Date: June 23, 2023

From: Andy Zdon, P.G., CEG, C.Hg.

Subject: **Proposed Ash Meadows Lithium Exploration**

Proposed Boring Locations

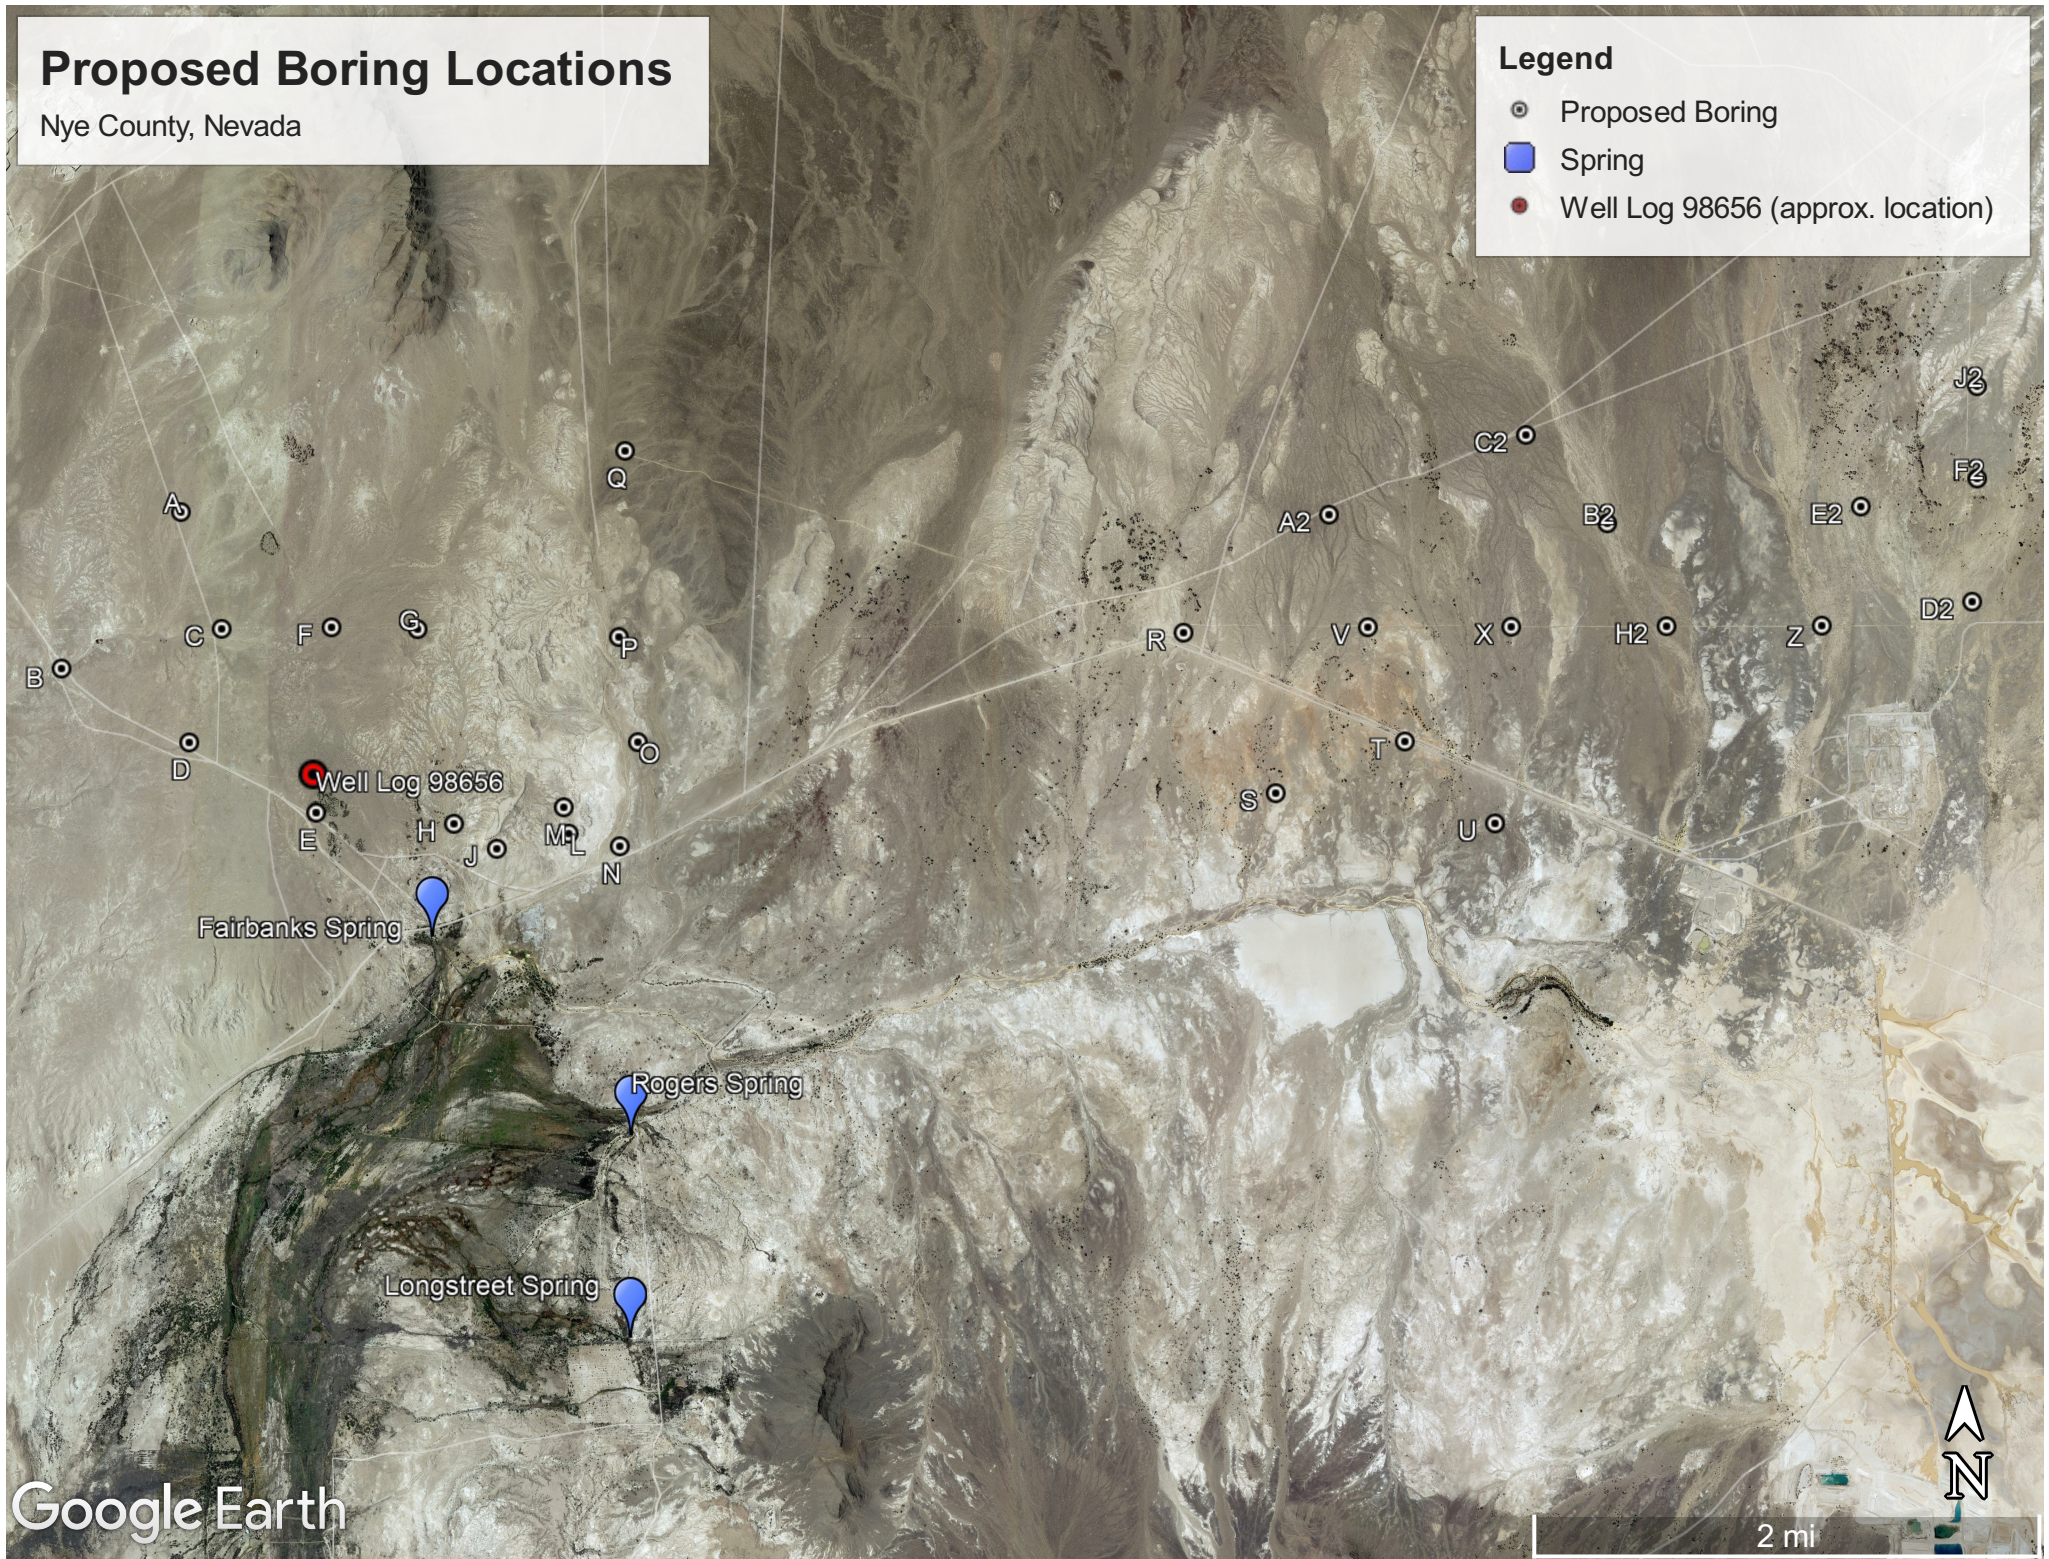
A geologic report was prepared by John Zimmerman of GenGold2, LLC for the “Let’s Go Lithium” Project (Zimmerman, 2022). This report provides a brief summary of conditions in the proposed drilling area, but gives little information related to the groundwater hydrology of the proposed project area relative to the Refuge. Of note is that drilling is proposed less than 2,000 feet from Fairbanks Spring in Ash Meadows.

Exploratory drilling, whether for minerals or groundwater development, can present significant challenges. The term exploratory is indicative that conditions are not fully known when initiating the work. As shown above and by the well log presented, it is likely that not only may groundwater be encountered during drilling, but there is a possibility if not a likelihood, that artesian conditions will be encountered. As described in the Borehole example presented above, unanticipated conditions can be present, and these uncertainties present risks, including in the case of the currently proposed project, to the springs at the Refuge.

Borings to the northeast of Fairbanks and Longstreet Springs present additional risk. One dual completion well was constructed for the U.S. Department of Energy (Well log 46842) where the well was screened at depths from 240 to 412 ft bgs in the shallow tube and at depths greater than 1,000 feet for the deep tube. Artesian flow was also encountered. Unfortunately, the log does not specify whether the deep, the shallow, or both tubes/completions were exhibiting that artesian flow, and this substantial data gap precludes using this well for further consideration and is not included on the attached figure. Beyond this well, there are no wells to compare with proposed minerals exploratory drilling, leaving significant unknowns about anticipated conditions that may be encountered.

Based on the uncertainties with hydrogeologic conditions in the area of drilling, the proximity to Ash Meadows National Wildlife Refuge and its regional springs, and past experience in the Amargosa Basin near Tecopa Hot Springs related to the Borehole, we believe that the proposed mineral exploration drilling north of Ash Meadows presents considerable risk associated with resources in the Refuge.

If drilling is allowed to proceed regardless of the risks involved, a work plan prepared by Rover that identifies measures to control unanticipated artesian groundwater discharge that is protective of resources in the Refuge should be developed and presented in a detailed work plan. Such a work plan should be concerned with not only Fairbanks Springs, but other springs such as Longstreet Spring, Five Springs and others in the wildlife refuge that fall within a radius similar in size to the radius area of the impacts that were observed in the Borehole by Tecopa Hot Springs. The drilling company should be fully prepared, with materials on-hand, to address any issues that arise resulting from artesian conditions encountered during exploration drilling.
